PROJECT SPECIAL PROVISIONS**ROADWAY****INCIDENTAL STONE BASE:**

ASPHALT PAVEMENTS - SUPERPAVE:

FIGURE 1: Safety Edge Detail

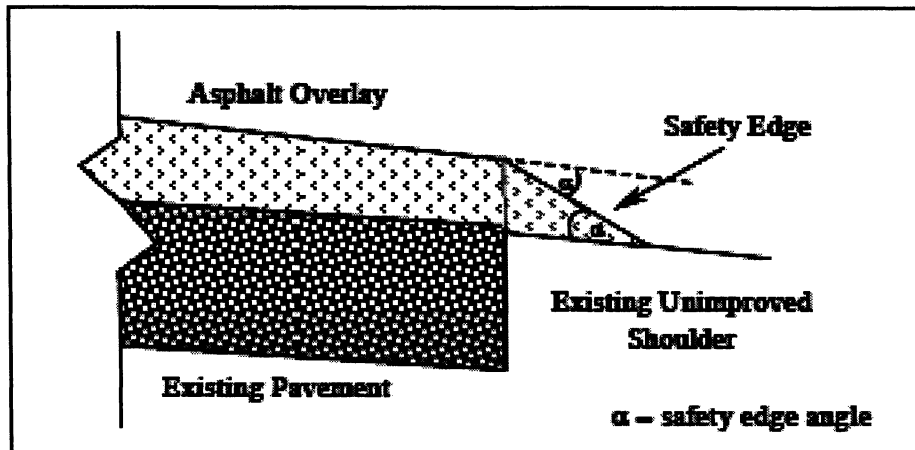
Page 6-44, Section 610-8 Spreading and Finishing, add the following to the fourth full paragraph:

measured from the horizontal plane in place after final compaction on the final surface course. Use an approved mechanical device that will form the asphalt mixture to produce a wedge with uniform texture, shape and density while automatically adjusting to varying heights.

See **Figure 1: Safety Edge Detail** for application of safety edge where edge of pavement is not restrained by curbing, curb and gutter, etc.
